Fuli Industrial Ltd.

25 August 2024

Observation-1: Inconsistencies in DEA report. (Production Building)

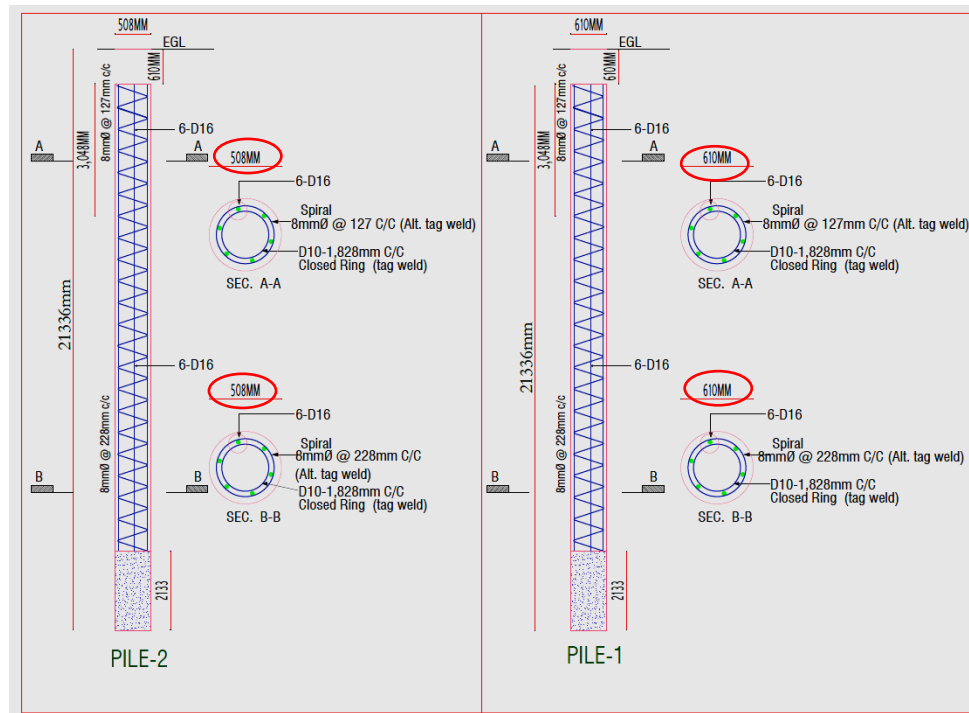
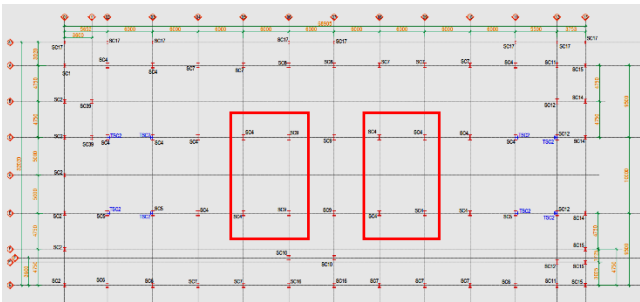
Description: The drawing provided shows two different diameter piles (508 mm and 610 mm). However, in the pile capacity checks, capacity was taken only for one type of pile (610 mm).

Item No.	Observation	Action Plan	Timeline
1.	Inconsistencies in DEA report. (Production Building)	The building engineer is required to address the inconsistencies in the revised DEA report; submit the revised DEA to the RSC.	within 6 weeks
		Carry out suggested remedial works if required.	within 6 months

Observation-2: Lack of information in as-built drawings. (Production Building)

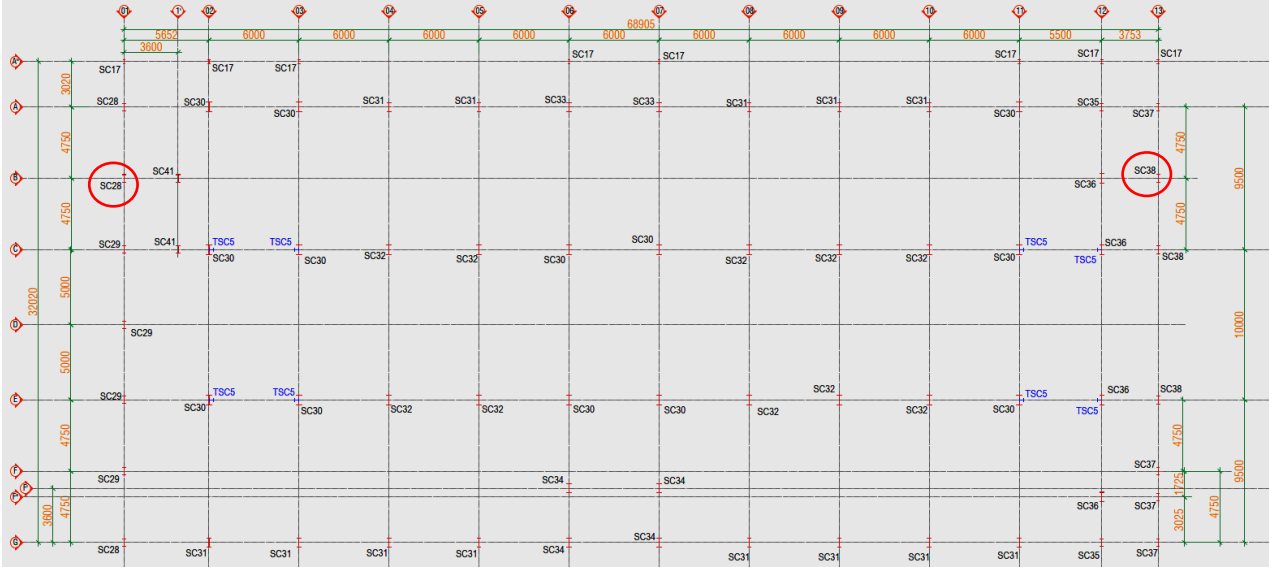
Description: In the provided as-built drawing portal frame was shown only at four locations. However, the portal frame was found in twelve locations on each floor.

The building engineer is required to survey the full structure and prepare complete as-built structure drawings. Also, provide construction drawings as the reference for the foundation.

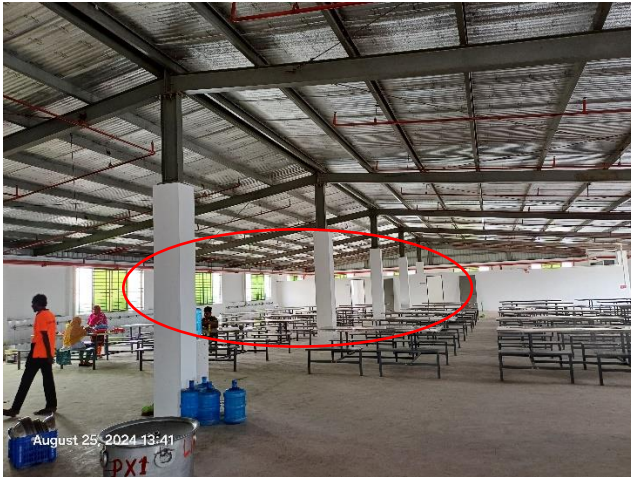
Description: In the marked locations an extra column was found connected to regular 'I' section.

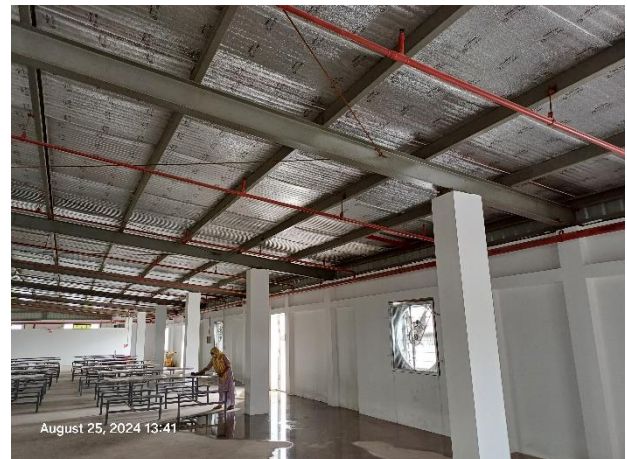
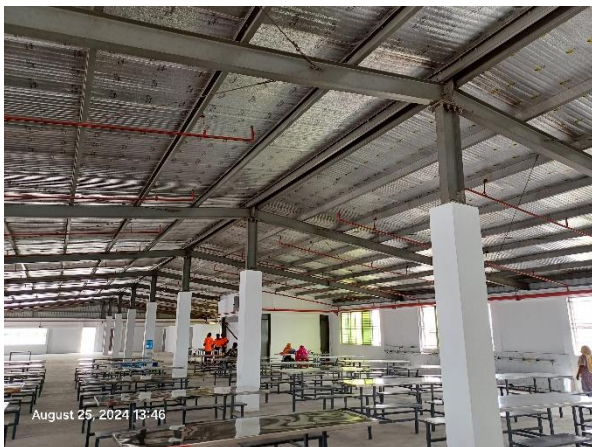
Description: Marked columns are RC columns at the roof level. But immediate below level columns are steel I-sections. No connection details were provided for the steel to RC column connections.

Observation-07: Corrosion on steel member. (Production Building)

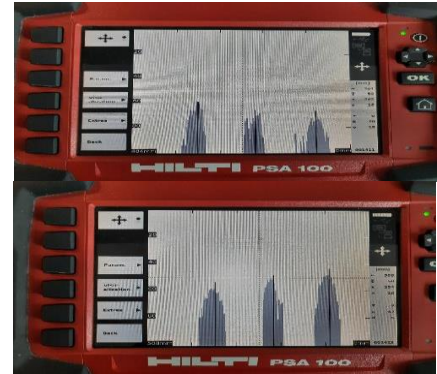
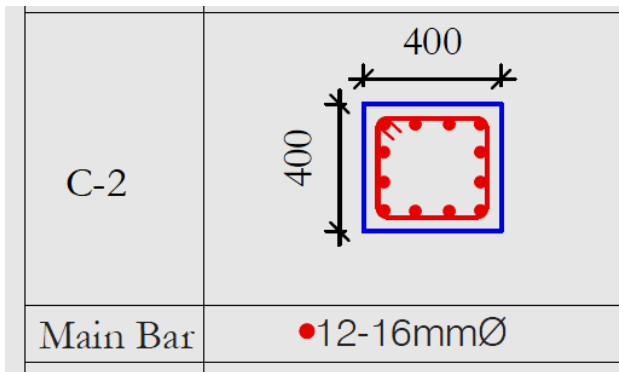
Description: Corrosion was observed on steel columns. The building engineer is required to remove the corrosion and provide rust-proof coating on corroded steel members to protect them from corrosion.

8.	Corrosion on steel member. (Production Building)	The building engineer is required to remove the corrosion and provide rust-proof coating on corroded steel members to protect them from corrosion.	within 6 weeks

Observation-09: Mismatches in as-built drawings. (Fire Pump Shed)

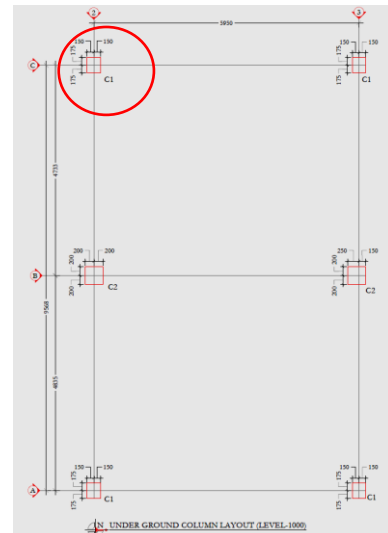
Description: C-2 type column rebar not matched with drawings. Three rebars were found at both faces instead of four. Building engineer is required to confirm the amount of re-bar in the column and update the drawing.

10.	Mismatches in as-built drawings. (Fire pump shed)	Building engineer is required to confirm the amount of re-bar in the column and update the drawing.	within 6 weeks

Observation-10: Damaged RC column. (Fire Pump Shed)

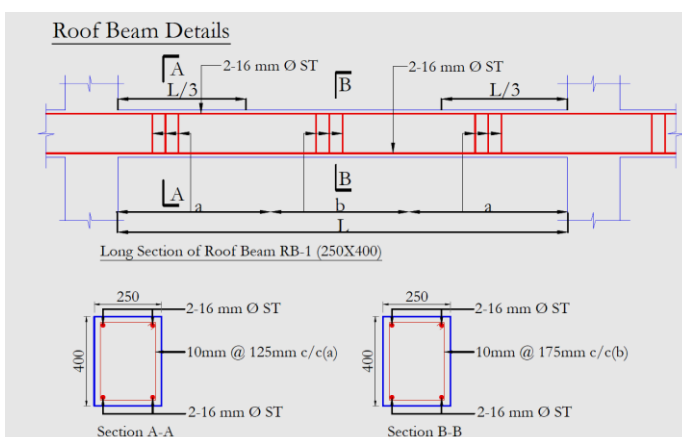
Description: A damaged column was found in the fire pump room. The building engineer is required to carry out suitable remedial work.

11.	Damaged RC column. (Fire pump shed)	The building engineer is required to carry out suitable remedial work.	within 6 weeks
12.	Mismatches in as-built drawings. (Guard room)	The building engineer is required to confirm the size of the roof beam and update the drawing.	within 6 weeks
